**SUBDIVISION,
PLANNED UNIT DEVELOPMENT, &
ZONING AMENDMENTS STAFF REPORT****Date: October 18, 2018**

<u>NAME</u>	Multiple Properties, LLC
<u>SUBDIVISION NAME</u>	Multiple Properties Oak Ridge Subdivision
<u>LOCATION</u>	4662 & 4666 Oak Ridge Road and 310, 314 316, 324, 328, and 330 South University Boulevard (Northwest corner of South University Boulevard and Oak Ridge Road).
<u>CITY COUNCIL DISTRICT</u>	District 6
<u>PRESENT ZONING</u>	Lot 1: R-1, Single-Family Residential District, B-2, Neighborhood Business District, and B-3, Community Business District Lot 2: R-1, Single-Family Residential District Lot 3: R-1, Single-Family Residential District
<u>PROPOSED ZONING</u>	Lot 1: B-2, Neighborhood Business District Lot 2: LB-2 Limited Neighborhood Business District Lot 3: R-1, Single-Family Residential District
<u>REASON FOR REZONING</u>	Lot 1: To eliminate split zoning. Lot 2: An increased need for business sites.
<u>AREA OF PROPERTY</u>	3 Lot / 9.6± Acres
<u>CONTEMPLATED USE</u>	Subdivision approval to create a three legal lots of record from five metes-and-bounds parcels; Planned Unit Development approval to allow multiple buildings on a single building site with shared access a

SITE PLAN

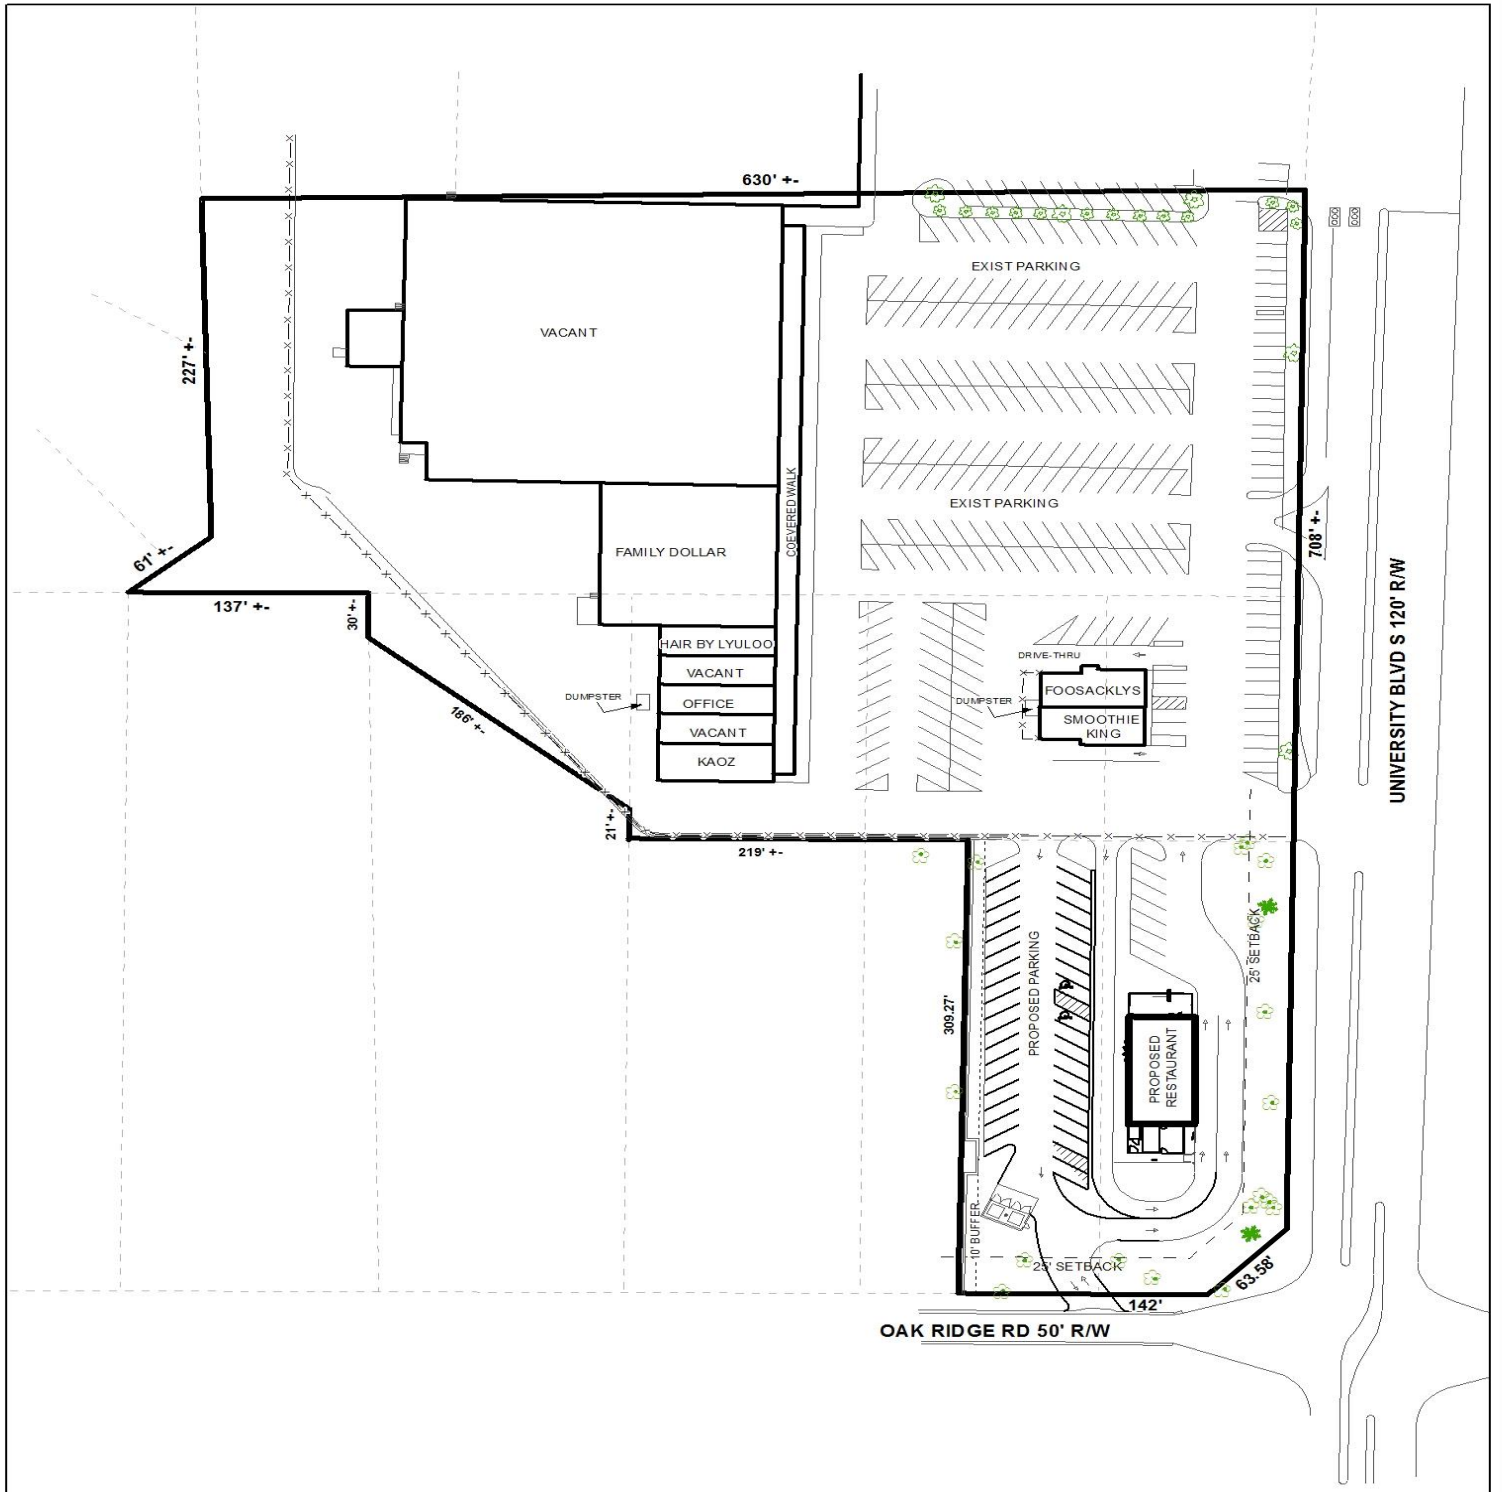
The lot sizes are provided in square feet and acres, and should be retained on the Final Plat, if approved. It should be noted that the square footage for proposed lots 1 and 2 differs on the preliminary plat and the site plan. If approved, this should be corrected. The 25' minimum building setback is depicted along all frontages, and should be retained on the Final Plat, if approved.

The site plan provided depicts the existing shopping center, freestanding building, and associated parking, as well as the proposed restaurant. The existing retail and restaurant uses require 222 parking spaces, and 239 are provided. The proposed restaurant will require 32 parking spaces, and 46 are depicted on the site plan. It should be noted that the site plan depicts the proposed restaurant as being 3,200 square feet, while the parking calculation information lists it as 3,000 square feet. If approved, a revised site plan should be provided with the size of the restaurant on the site plan that matches that listed in the parking summary calculations. As the site will have more than 25 parking spaces, full compliance with Section 64-6.A.8. of the Zoning Ordinance will be required. A photometric plan for the proposed restaurant site will be required at time of submittal for land disturbance permits.

A dumpster is depicted on the site plan for the proposed restaurant. The location of the dumpster has been shifted to the West, closer to the proposed (residential) Lot 3, than the previously proposed site plan. The dumpster and enclosure must comply with Section 64-4.D.9. of the Zoning Ordinance.

The proposed Lots 1 and 2 abut R-1, Single-Family Residential properties, therefore a compliant residential buffer should be provided. The site plan illustrates an existing fence along the West and South property lines of the proposed Lot 1, but should be revised to remove the portion that abuts the proposed Lot 2, and include the height of the wood fence. A decorative masonry wall is depicted where Lot 2 abuts R-1 properties, but no mention is made of the proposed height. If approved, the wall should be a minimum of 6' high, being reduced to 3' in height within the front setback, if approved.

It should be noted that a sidewalk will be required along both University Boulevard and Oak Ridge Road at the time Lot 2 is developed, therefore the site plan should be revised to depict a sidewalk.

It should be noted that the proposed Lot 2 will have to fully comply with tree planting and landscape area requirements at the time of development. There are several existing trees depicted on the site that, if retained, will exceed the minimum tree plantings required for the site. Staff recommends that the site plan be revised to show the canopies of these trees in addition to

Because the proposed use of Lot 2 is a drive-thru restaurant, the site plan should be revised to depict the location of the menu board and the pickup window so that staff can make sure that there are sufficient queuing spaces for each. A queuing space is 9'x20', and three (3) queuing spaces are required for the menu board as well as the service window.
